SERVICE INFORMATION

STANDARD AND TRIUMPH VEHICLES

No.	SPORTS/8/B.	ROCKER COVER GASKET	Date	JUNE 1955
------------	-------------	---------------------	-------------	-----------

No.	SPORTS/9/B.	ROCKER SHAFT PEDESTAL STUDS	Date	JUNE 1955
------------	-------------	-----------------------------	-------------	-----------

1 ILLUSTRATION

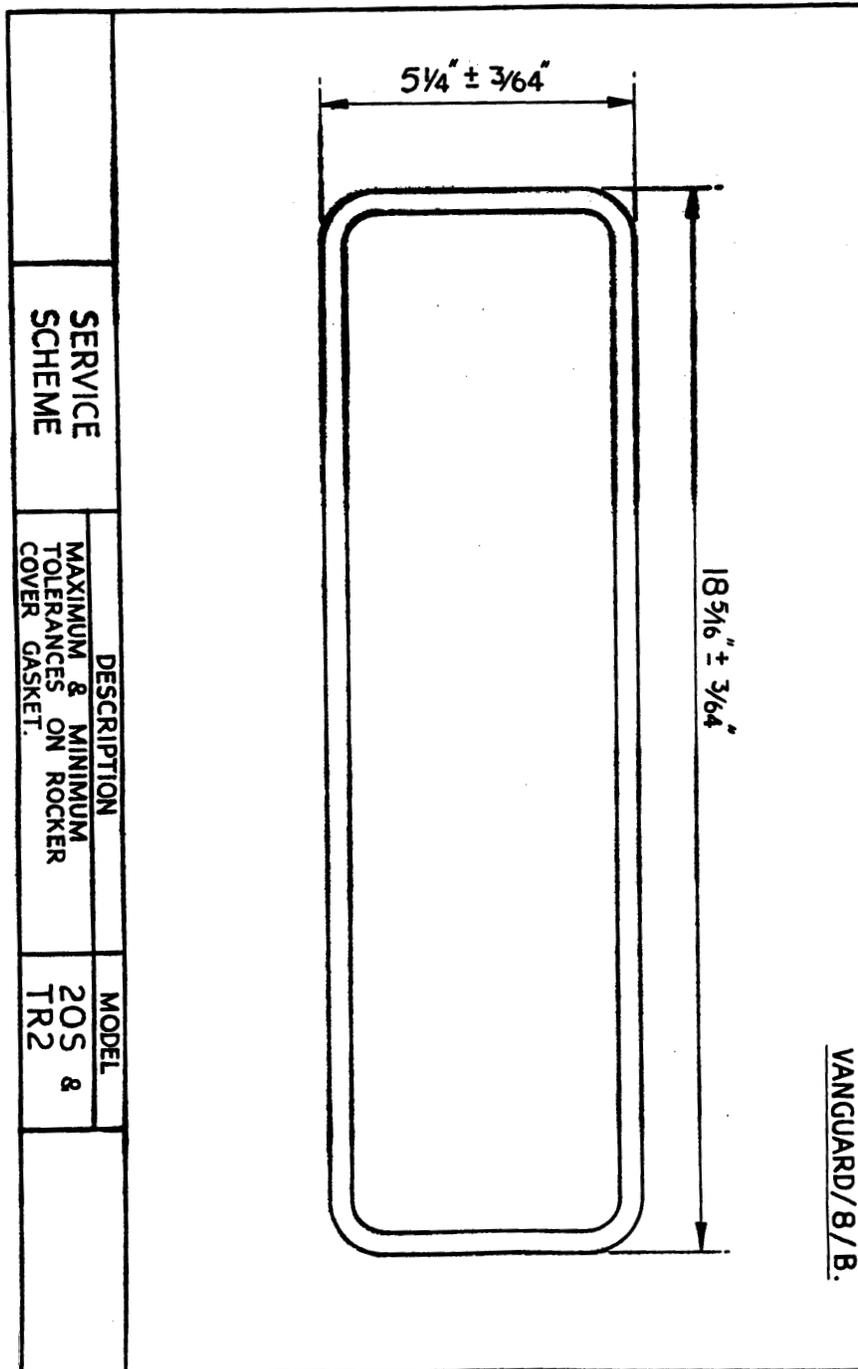
Reports of oil leakage past Rocker Cover Gasket, Part No. 55943, have been investigated. It has been found that certain consignments of gaskets received from our suppliers have been cut from cork materials which had an excessive moisture content. As a result, when this moisture content dries out, the gasket material shrinks either after fitting on the engine or during long periods of storage.

Packages of gaskets now being received are marked with the letters "TD" on the wrapping, denoting that the moisture has been dried out of the cork material by Tunnel Drying before cutting.

In order that gaskets may be checked for size, before fitting to an engine, the correct dimensions are given in the illustration.

SECTION THRO' CENTRE BEARING	& CRANKSHAFT
SHEET 1 OF 3 SHEETS	
SALVAGE OR SERVICE SCHEME:	DESCRIPTION:
TO SALVAGE: NORMAN CAMSHAFT BRG HOUSINGS IN CYLINDER BLOCK	MODEL:
TO SALVAGE:	20 5 & 20 TR 2

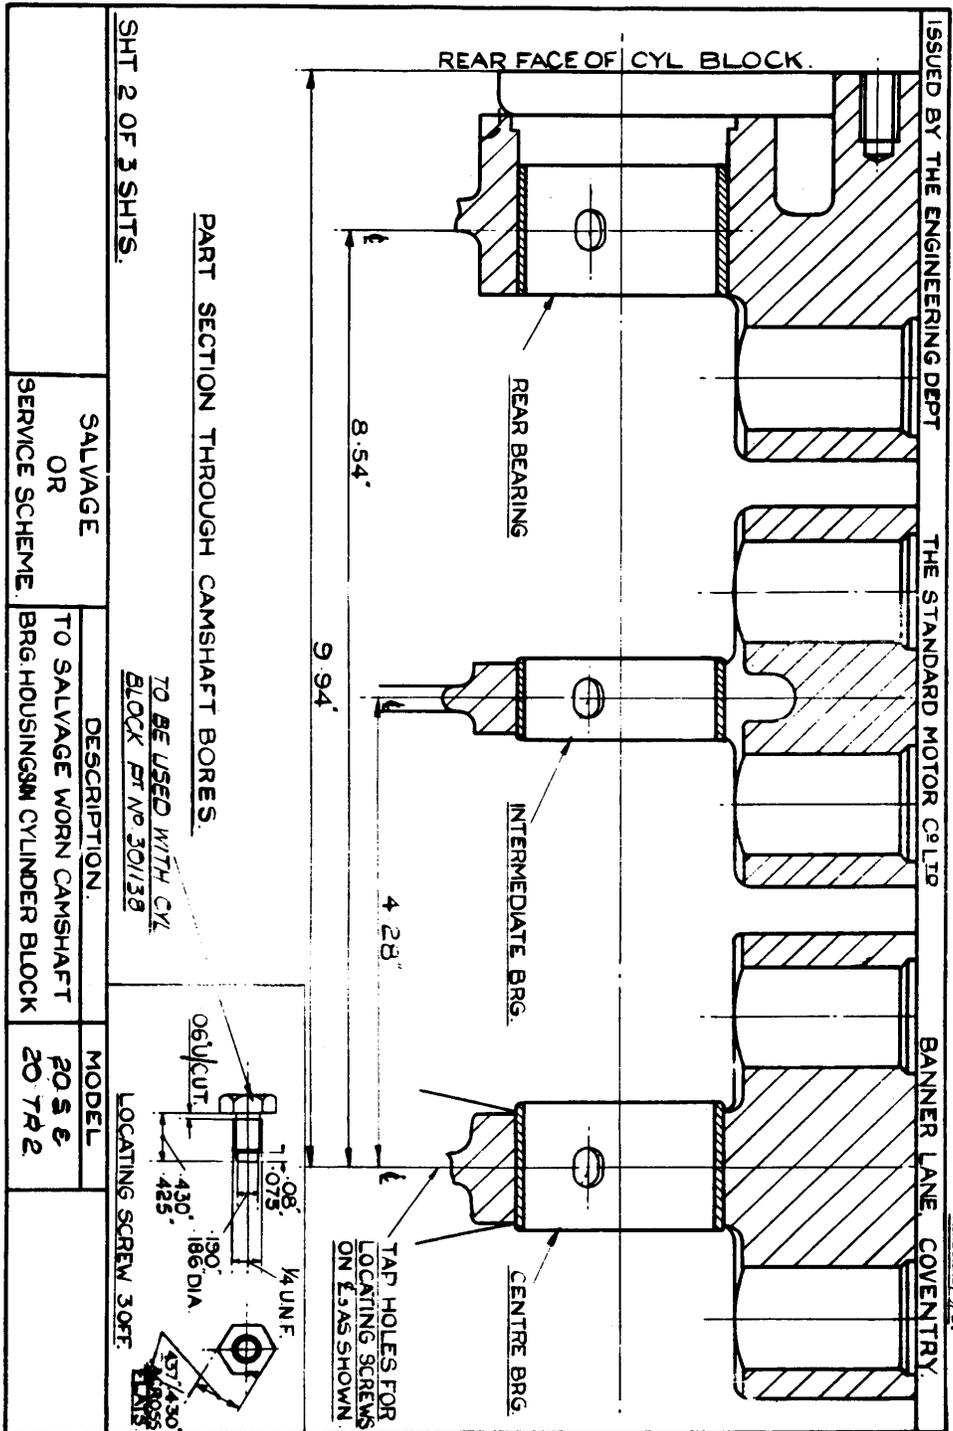
Where camshaft bearing housings have worn excessively, the bores will require line-boring to accommodate pre-finished bushes. In view of the fact that this salvage work involves precision machining it is suggested that it would be best met, in this country, by obtaining a replacement engine from our Spares Department under our Unit Exchange Scheme. On the other hand, where such work is required in overseas countries, it should only be attempted by a firm of specialists in such matters.

It should be noted that since the bushes which our Spares Department supply are of the pre-finished type no further machining is necessary after fitting to the cylinder block. The front detachable bearing, Part No. 60214, will also require renewal where it is worn excessively.

When contemplating the reconditioning of a cylinder block, the existence, or the non-existence, of the bosses for the pre-finished locating screws should be established as a different locating screw is required for each type. The machining dimensions for Cylinder Block, Part No. 371138, are given on Sheet 1 of the illustrations and those for Cylinder Block, Part No. 301487, which has the bosses for the locating setscrews, are given on Sheet 3 of the illustrations. Particular note should be paid to the correct relationship of the oil feed holes and the fitting of the locating screws.

ISSUED BY: THE ENGINEERING DEPARTMENT. THE STANDARD MOTOR CO LTD, BANNER LANE, COVENTRY.	
CYLINDER BLOCK PART NO 301138 (205) & 301140 (20TR2)	
SEQUENCE OF OPERATIONS TO FIT NEW BEARINGS FOR CAMSHAFT	
<ol style="list-style-type: none"> 1 COMPLETELY STRIP DOWN ENGINE. 2 MOUNT CYLINDER BLOCK ON SLIP FACE AND LINE BORE 3 BEARING HOUSINGS TO 18443' / 18435' DIA AND TO LOCATING DIMENSIONS AS SHOWN ON SECTION OF CYLINDER BLOCK. 3 WITH SUITABLE VIG DRILL, TAP AND SPOT FACE 3 HOLES TO DIMENSIONS GIVEN 18, IN CENTRE, INTERMEDIATE, AND REAR BEARING POSITIONS. 4 CLEAR OUT SWAGE ETC (OILWAYS IN PARTICULAR) 5 PRESS FIT 3 NEW PRE-FINISHED BEARINGS (PART NOS BELOW) IN CORRECT RELATIONSHIP TO OIL FEED HOLE AND LOCATING SCREW HOLE PARTS REQ. CAMSHAFT BEARING INTERMEDIATE PT. NO 110700 CAMSHAFT BEARING CENTRE & REAR PT. NO 110699 SPECIAL BOLT AS DRAWN ON SHEET 213. WASHER 1/4" X .063" THICK WP 0023	
NOTE: 1 IT IS IMPORTANT WHEN FITTING RETAINING SCREW THAT THE LOCATING END DOES NOT PROTRUDE INTO THE BEARING BORE. 2 NO FURTHER MACHINING WILL BE REQUIRED ON BEARING WHEN FITTED

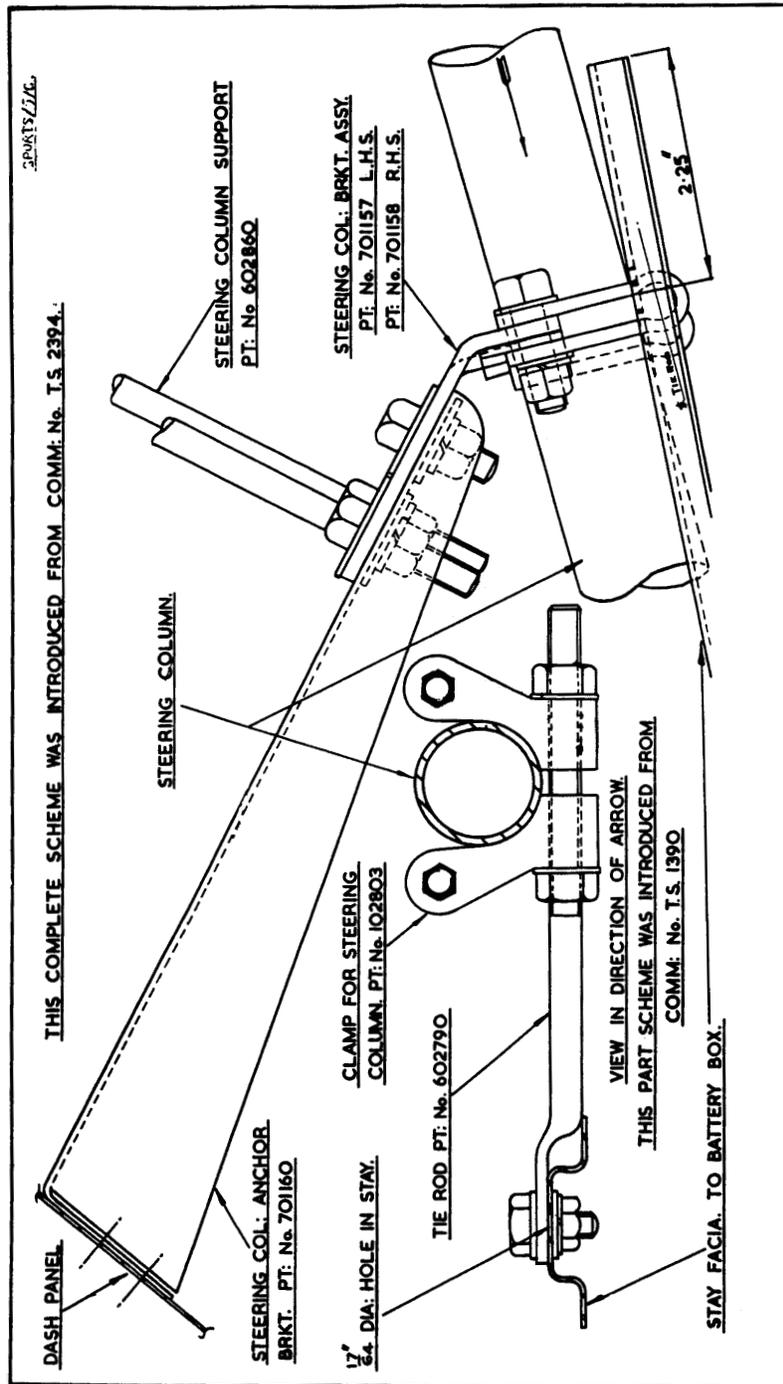
Having completed and adjusted the modified upper steering column support details satisfactorily, assemble Tie Rod, Part No. 602790, as shown in the illustration.

In order to fit the lower column support bracket proceed as follows:

- 1) Dismount the lower wishbone assembly from the frame and remove the road spring at the affected side of the car. (R.H.S. or L.H.S.)
- 2) Disconnect the right hand or left hand track rod respectively from the centre track rod for right hand or left hand steering Models.
- 3) Set the steering at full right hand or left hand lock for right hand or left hand steering Models respectively.
- 4) Utilise a 1/32" twist drill, extending 6" from the chuck, to drill a hole in the fixing flange positioned, as shown in the appropriate illustration, to suit the steady bracket attachment. The upper bracket is obtainable handed to suit right or left hand steering, but in other respects they are identical.

1 ILLUSTRATION.

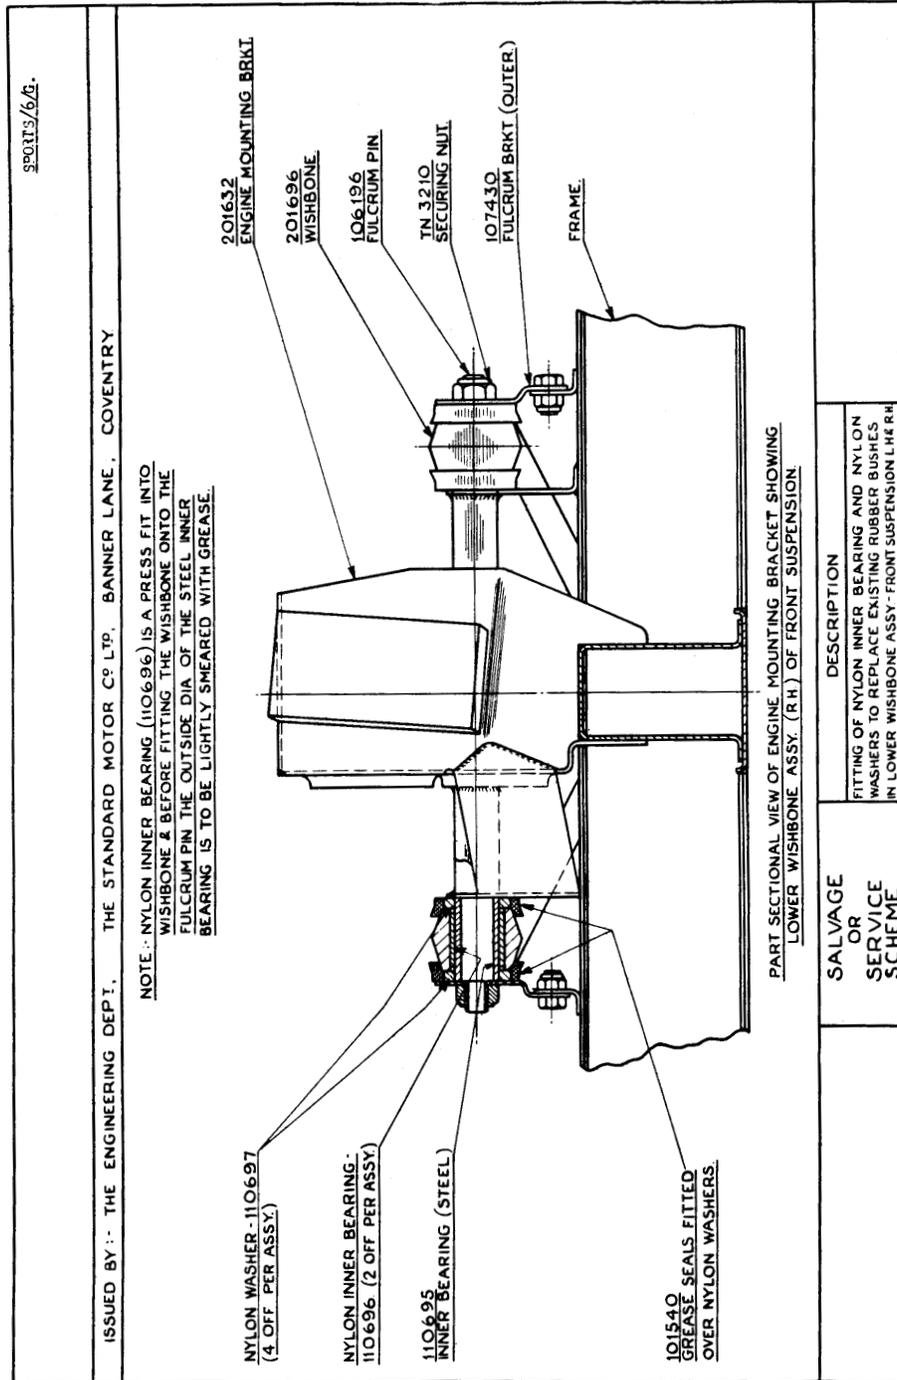
The original rubber bushes, Part No. 102228, fitted to the bottom inner fulcrum have now been replaced, in normal manufacture, by bearings of nylon material which provide better bearing qualities and consequently have a longer useful life.

The nylon type bearing was introduced in normal manufacture at Commission No. TS.9121. This modification can be made with cars prior to the Commission Number quoted above where normal replacements are required.

When refitting the wishbone arms, care should be taken to ensure the correct end float at the bottom outer fulcrum position as described in Service Information Sheet SPORTS/4/G.

1 ILLUSTRATION.

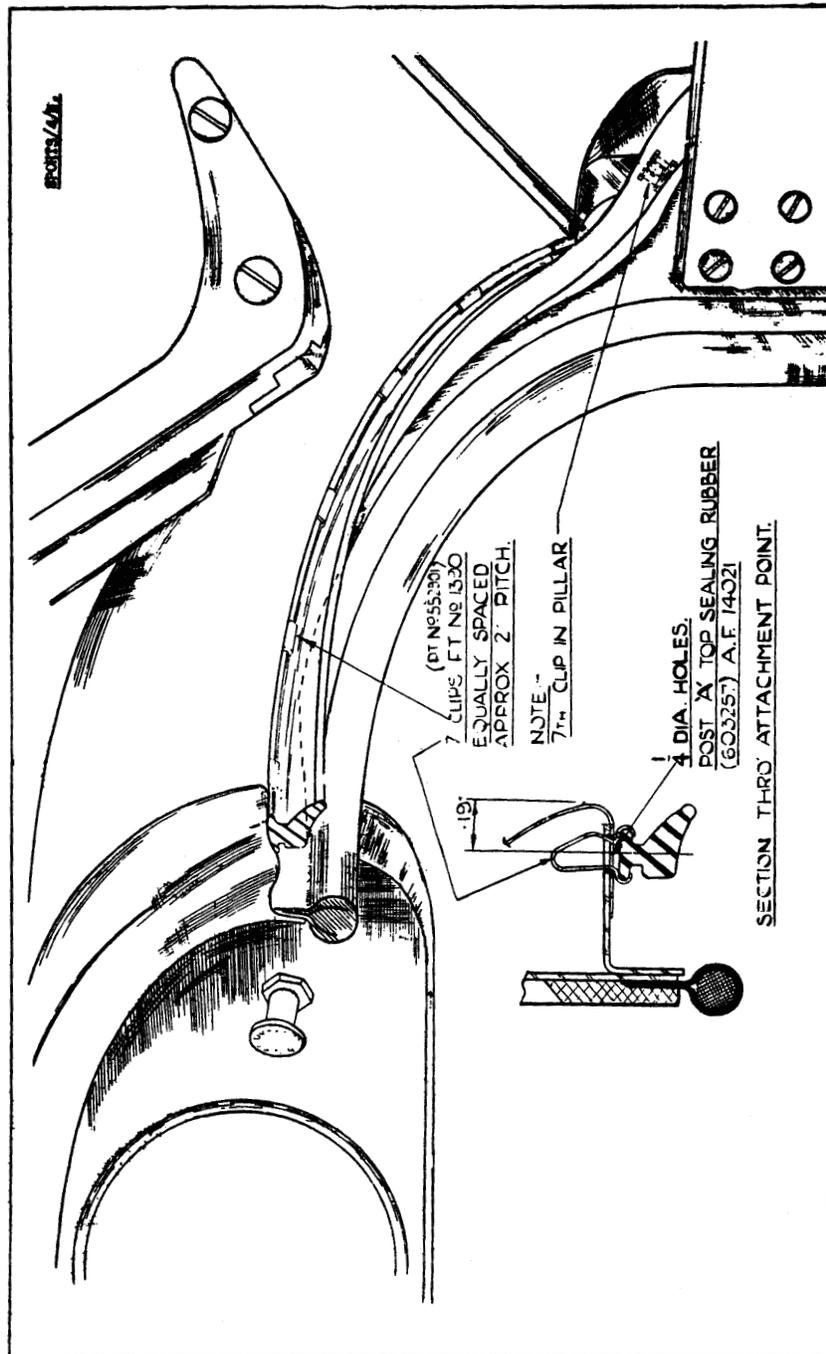
Additional water sealing of the front doors has been introduced in normal manufacture and this modification can be carried out as necessity demands with cars released prior to its introduction.

2 ILLUSTRATIONS.

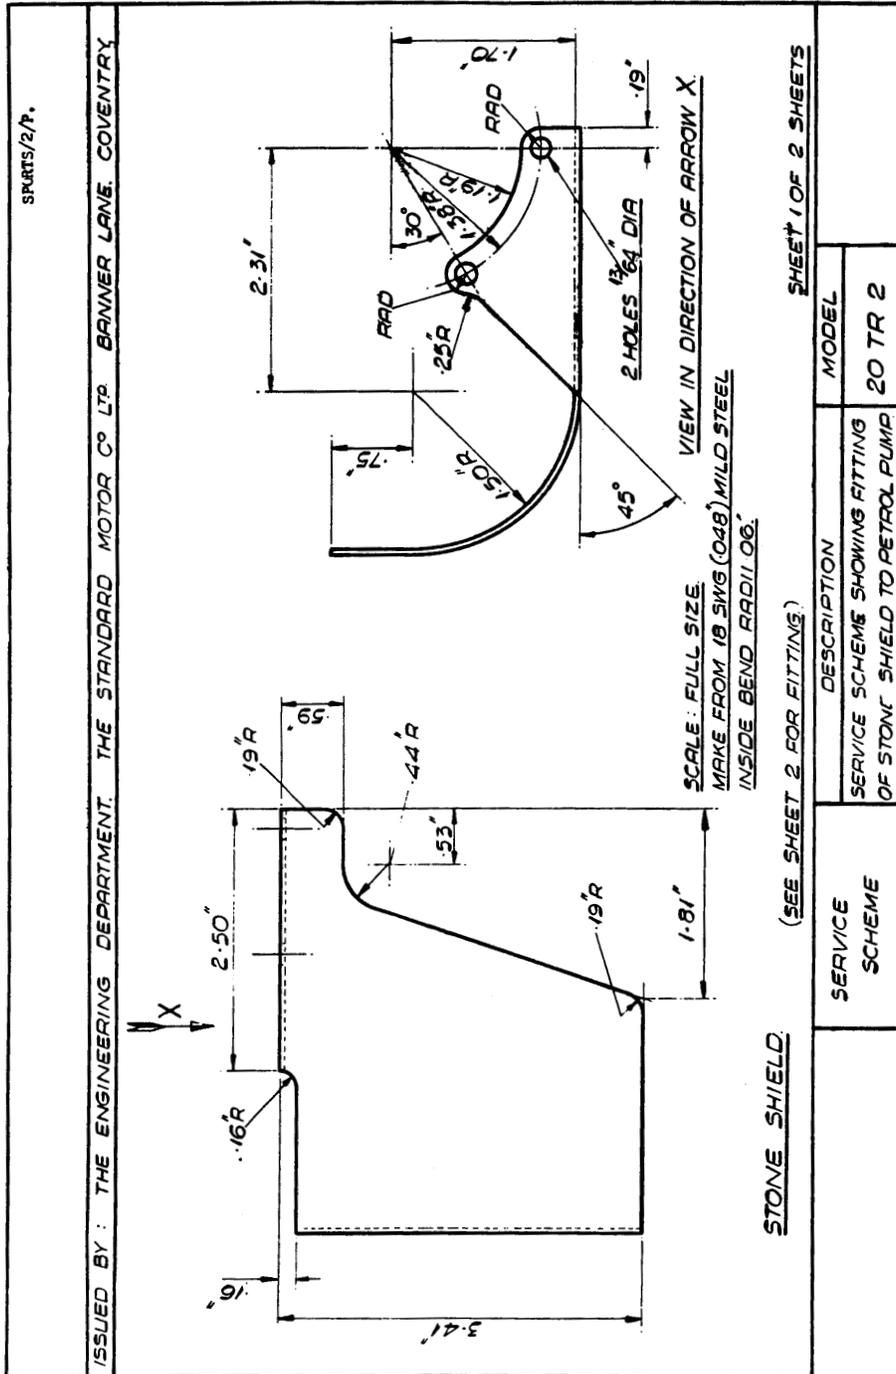
Owners who contemplate entering the car for rally events would be well advised to fit such a shield and thus eliminate the possibility of trouble in this connection.

SPORTS 12/P.	ISSUED BY : THE ENGINEERING DEPARTMENT THE STANDARD MOTOR CO LTD BANNER LANE COVENTRY		SEE SHEET 1 FOR DIMMS OF STONE SHIELD	SHEET 2 OF 2 SHEETS	
THE SHIELD IS FITTED TO TWO OF THE TOP COVER SECURING SCREWS AS SHOWN. THESE SCREWS ARE OF SUFFICIENT LENGTH TO ACCOMMODATE THE THICKNESS OF THE STONE SHIELD. THE SHIELD MUST BE REMOVED TO GAIN ACCESS TO THE FILTER BOWL.		STONE SHIELD IN FITTED POSITION.	SERVICE SCHEME	DESCRIPTION SERVICE SCHEME SHOWING FITTING OF STONE SHIELD TO PETROL PUMP	MODEL 20 TR 2
